STATE OF HAWAII
DEPARTMENT OF LAND AND NATURAL RESOURCES
OFFICE OF CONSERVATION AND COASTAL LANDS
Honolulu, Hawaii

July 22, 2009

REGARDING:	Conservation District Use Application (CDUA) MA-3498 for a Single Family Residence (SFR) & Related Improvements
APPLICANT/ LANDOWNER:	Warren & Susan Dean James & Jeanne Riley
LOCATION:	Olowalu, Lahaina, island of Maui
TMKs:	(2) 4-8-003:045
AREA OF PARCEL	Approximately (≈) 0.803-acre/ 34,978-ft²
USE:	≈ 8,000 ft²
SUBZONE:	Limited

CONCEPTUAL GRADING, DRAINAGE AND BEST MANAGEMENT PRACTICES PLAN

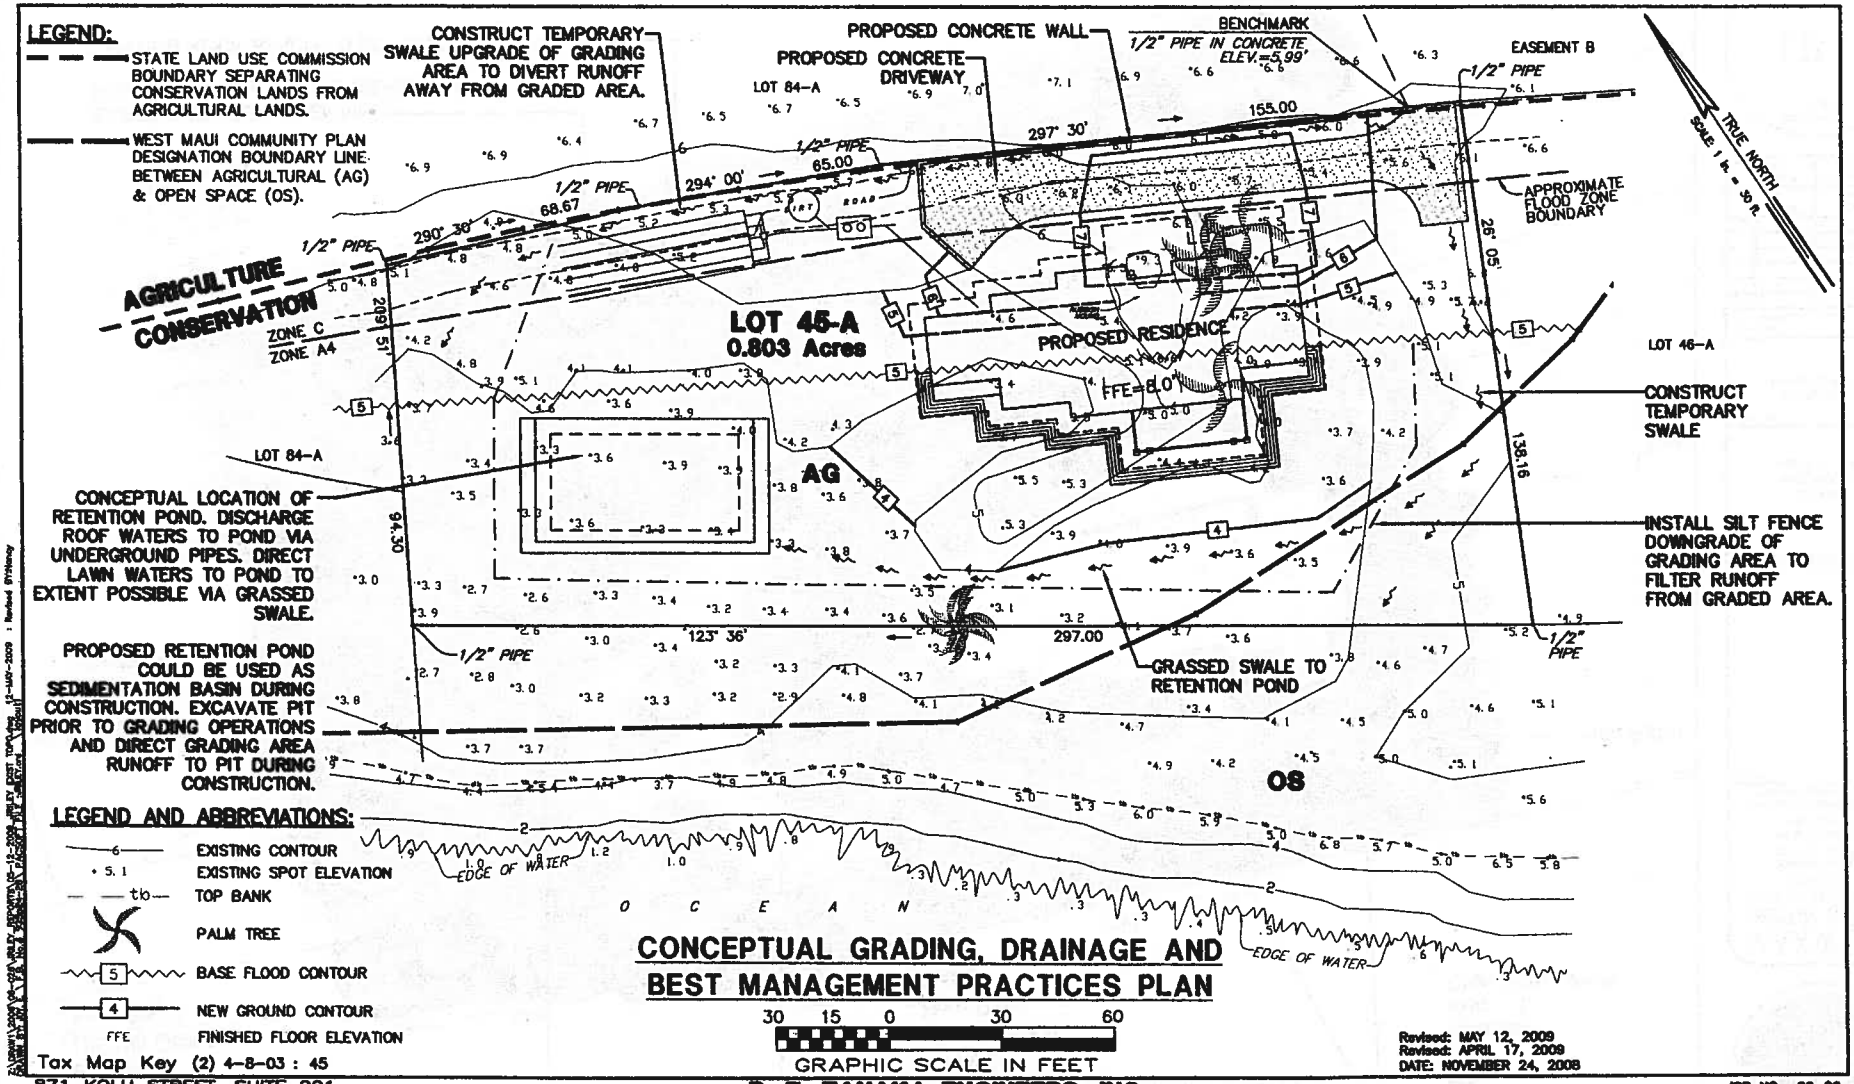
Although the structure has been elevated six feet higher, to keep it above flood waters, the septic tank and leach field is still located below anticipated flood water levels. If the septic tank and leach field are inundated by floodwaters, I suspect that the system will stop working and there is potential for a sewage leak.

The Department also notes a 1250-gallon aerobic septic tank and leach field at the far north end of the property. The elevation ranges from 4'-5' above sea level. The influences of sea level rise on the water table and thus the ability of the wastewater system to adequately discharge and function over the life of the residential structure should also be considered in the CDUA.

The site plan has been revised to locate the septic tank and leach field so that it is outside of the A4 flood zone at a slightly higher existing grade elevation. Therefore the wastewater disposal system will no longer be in a flood zone and potential for flooding should be extremely low. In the event that flooding of the area were to occur, the potential for direct discharge to flood waters would be related to the height of the floodwaters in relation to fixture outlets in the residence. Floodwaters would saturate the soil and absorption beds or trenches and there would be a potential for the waters to back up in the wastewater system until it reaches the height of the floodwaters.

The site plan has been revised to locate the septic tank and leach field outside of the A4 zone at a slightly higher existing grade elevation. The applicant is proposing aerobic treatment of the effluent and as such, there is no minimal requirement for separation between the bottom of the leach field and the groundwater table. However, in order for the system to adequately discharge, the bottom of the leach field will be established at ≈ 3-feet above the existing water table. Cover material will be used to mound over the leach field.

CROSS SECTION
DEAN / RILEY OLOWALU LOT 45-A
SINGLE FAMILY RESIDENCE

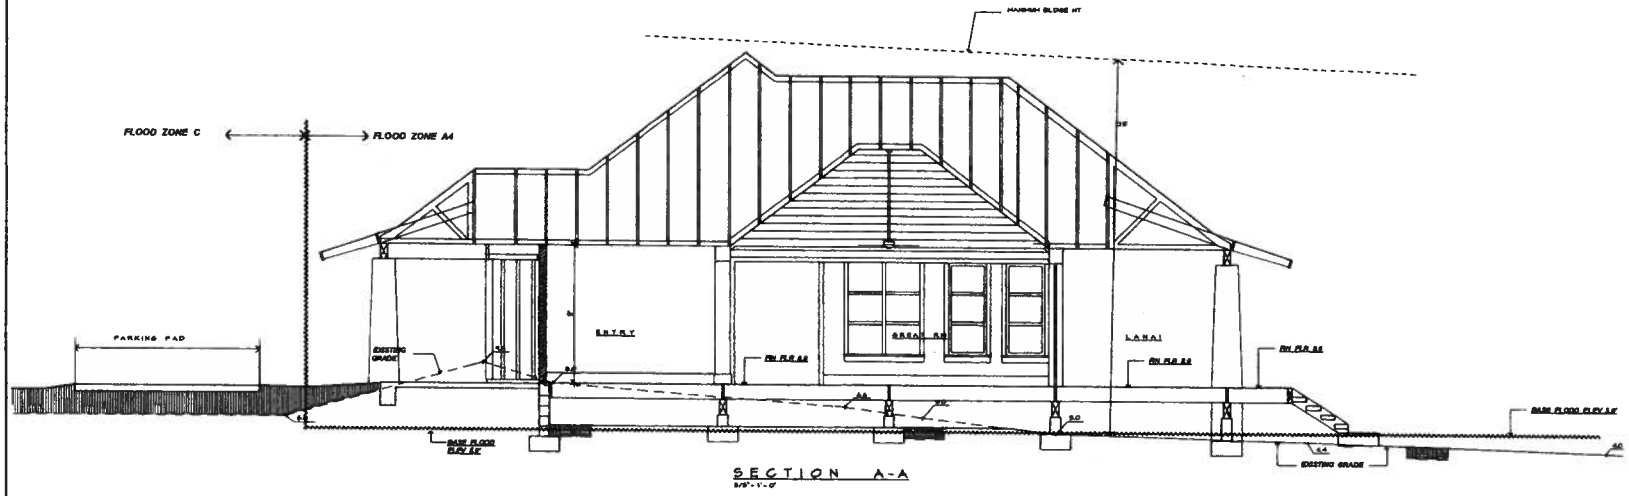
The OCCL notes both the County and State have recommended post on pier construction yet the proposal continues to grade approximately 8000 ft^2 and import approximately 60 yd^3 of fill to elevate the foundation up to 1.5-ft to comply with designated flood standards. Residences have an expected lifespan of 70-years. This is a high water table area with evidence of marsh condition soils. Comments received from various agencies indicate there is a concern regarding the conditions of the land and the potential affects to the residence and the wastewater system during the lifespan of use as a residence. Discuss this preference to infill vs. the suggested post on pier in regards to the expected rise of the water table due to sea level rise and reach. What are the potential affects to the residence, the wastewater system and infill and how will these potential affects be mitigated to insure the residents and the general public's health, safety and welfare and to insure that the ocean resource shall not be compromised?

Post and pier construction is more appropriate in flood prone areas than slab on grade accompanied by grading and fill. The proposed residence is transected by Flood Hazard Zone A4 and C. The base flood elevation is listed as 5.0 feet and the structure's pad after grading is 6.5 feet. Thus the proposal is to create a pad to elevate the slab on grade house above floodwaters. The same can be accomplished with post and pier construction. However, post on pier structures can be relocated during the buildings life span whereas slab on grade cannot.

The proposed construction style of the residence has been amended from slab on grade to a post and pier type structure. In addition, the finish floor elevation has been raised to 8-feet above sea level.

The proposed construction style of the residence has been amended to a post and pier type structure. In addition, the finish floor elevation has been raised to minimum of 8-feet above sea level.
